Planning Report

Ballantrae, Subarea S and Liggett Property Development

Agenda Item	3
Case Number	14-083INF
Proposal	A potential residential development of 141 detached condominiums and single family lots on approximately 49 acres.
Request	Informal review and feedback on a potential future rezoning application.
Site Location	Northeast corner of Rings Road and Cosgray Road intersection, east of railroad tracks
Owner/Applicant	Schottenstein Homes, represented by Jack Reynolds and Paul Coppel
Case Manager	Devayani Puranik, Planner II (614) 410-4662 dpuranik@dublin.oh.us
Planning Recommendation	Discussion and Feedback

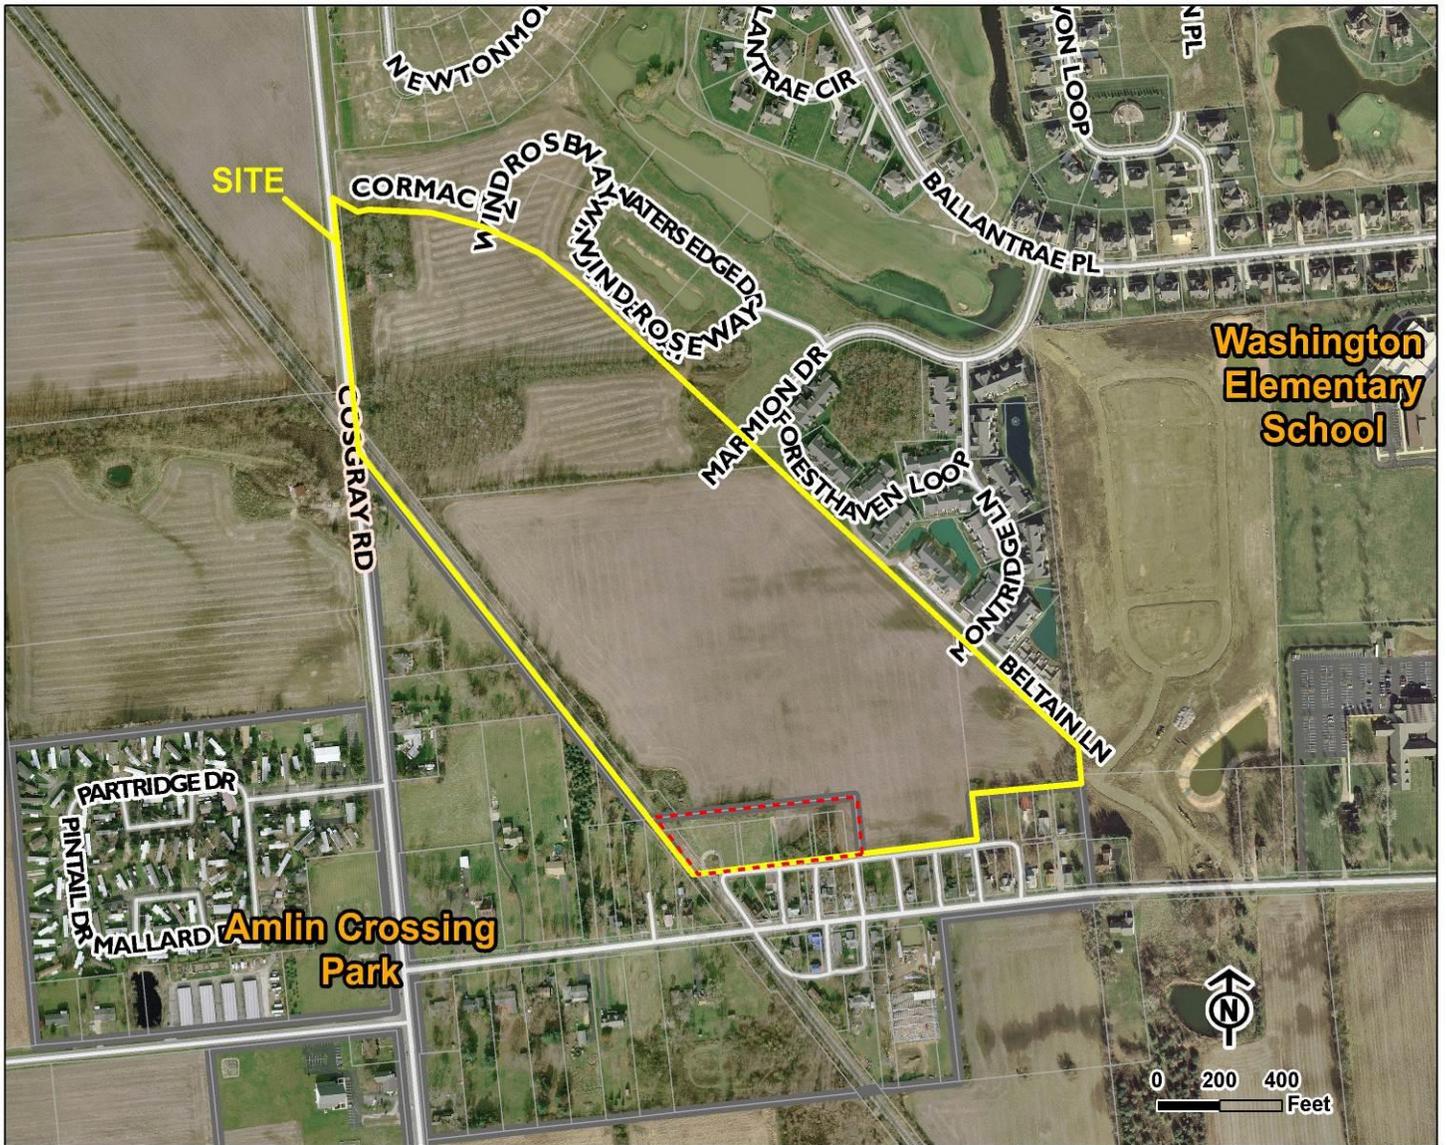
Analysis		Informal
General	<p>Planning recommends the Commission consider this proposal with respect to the site layout, design features, architectural concept, and compatibility with surrounding development. The following analysis provides additional details.</p>	
<p>Layout <i>Discussion Questions</i> 1. Should the development be more integrated?</p>	<p>Planning supports the proposed use and density. The recommended future land use for the site is Mixed Residential Medium Density where greater walkability and pedestrian orientation at a village scale are desired.</p> <p>The development may benefit from a more integrated approach of mixed residential development reflecting village residential character as opposed to isolating sections for single family and condominium uses.</p> <p>This integrated approach can also be for open spaces, especially for preserved open space which can become a great amenity by providing passive recreational opportunities and pedestrian connections continued through the setbacks and other open spaces.</p>

Analysis	Informal
<p>2. What should be the character of the western and southern setback?</p>	<p>The buffer treatment for the CSX railroad tracks along western property line can be in the form of mounds, fence, and evergreens and, wherever possible, through mature tree rows. A 100-foot setback from the railroad was recently been approved by the Commission for a multiple family development.</p> <p>The street along the southern property line is used as an alley by the Village of Amlin residents. A few large residential lots with minor commercial fronting on Rings Road back onto the alley. Approximately 50 feet setback is proposed from the alley on the site plan. The Southwest Area Plan recommends that the future residential development in the area should provide adequate separation with open space to visually define a clear transition between traditional neighborhood design and the surrounding area.</p>

<p>3. What are the possible options to improve the connectivity?</p>	<p>The site plan shows a network of public and private streets. Engineering prefers public streets for entire development to simplify maintenance responsibilities.</p> <p>An additional vehicular connection will be needed between single family and condominium sections to improve connectivity. The right angle street turns within the condominium section should be avoided. Also, the street connections around the gazebo area should be reworked for better traffic distribution.</p> <p>The Southwest Area Plan illustrates an additional connection to Rings Road from proposed development. This connection can be vehicular or pedestrian. Since the Rings Road and Churchman Road intersection is proposed to have a roundabout, it may be appropriate to direct the traffic from proposed development to Churchman and further to Rings Road. A pedestrian connection may work well for the residents to access village commercial along Rings Road when it develops as envisioned.</p>

<p>Architecture 4. Is the proposed architectural concept appropriate to the surrounding area?</p>	<p>The proposal includes architectural illustrations for the detached condominiums. There are variations shown for building forms, garage orientation, windows placements, and dormers with consistent visual theme followed through. The color and materials palate consists of natural materials and tones.</p>
